UNITED STATES PATENT AND TRADEMARK OFFICE

APPLICATION NO.	FILING DATE	FIRST NAMED INVENTOR	ATTORNEY DOCKET NO.	CONFIRMATION NO.
10/781,368	02/18/2004	Krista Nash	14318	2773

Office Action Summary

FIG. 1

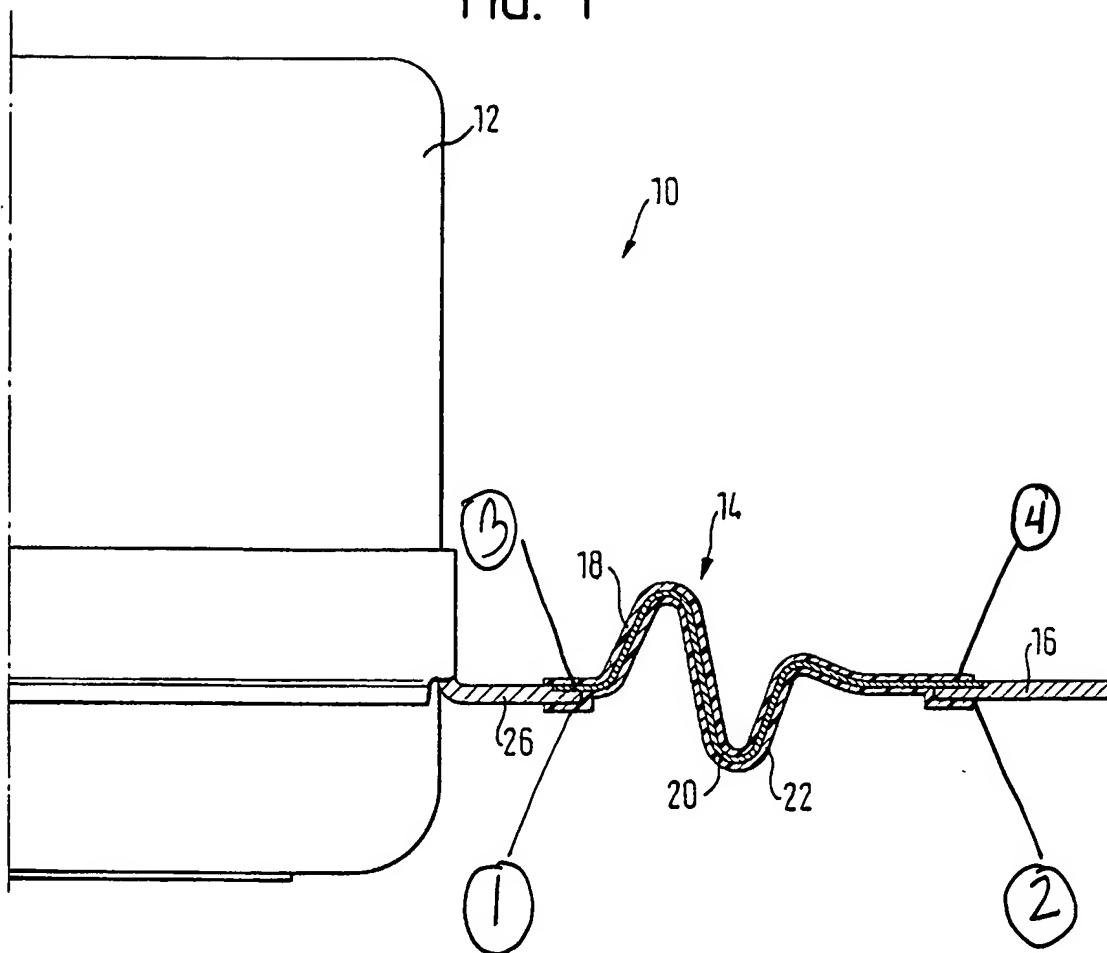
9. Claims 1-3, 11, 14, 17-20, 22-23, and 33 are rejected under 35 U.S.C. 102(b) as being anticipated by Hauer (US 6,811,181). Regarding claims 1, 11, 14, 17, and 23, Hauer discloses an airbag vibration gasket (14) including: a first surface (see attached marked up Figure 1) that is attachable to an airbag inflator (12) via an inflator flange (26), a second surface (see attached marked up Figure 1) that is attachable to an airbag mounting plate (16), and at least one foil strip (20, col. 3, lines 44-46) having an inflator interface area (see attached marked up Figure 1) and a mounting plate interface area (see attached marked up Figure 1), the inflator interface area being between the first surface and the inflator and the mounting plate interface area being between the second

surface and the mounting plate (see Figure 1). Regarding claim 2, Hauer discloses the gasket is ring-shaped (see Figure 3). Regarding claim 3, Hauer discloses the gasket being designed to encircle a bottom portion of the inflator (see Figure 3). Regarding claim 18, Hauer discloses having a foils strip that wraps around the gasket (col. 3, lines 40-45). Regarding claim 19, Hauer discloses the foil strip is made of an electrically conductive metal (col. 3, lines 44-49). Regarding claims 20 and 33, Hauer discloses the foil strip operating to electrically ground the inflator (col. 2, lines 49-51). Regarding claim 22, Hauer discloses making the gasket out of an elastomeric material (col. 3, lines 13-15).
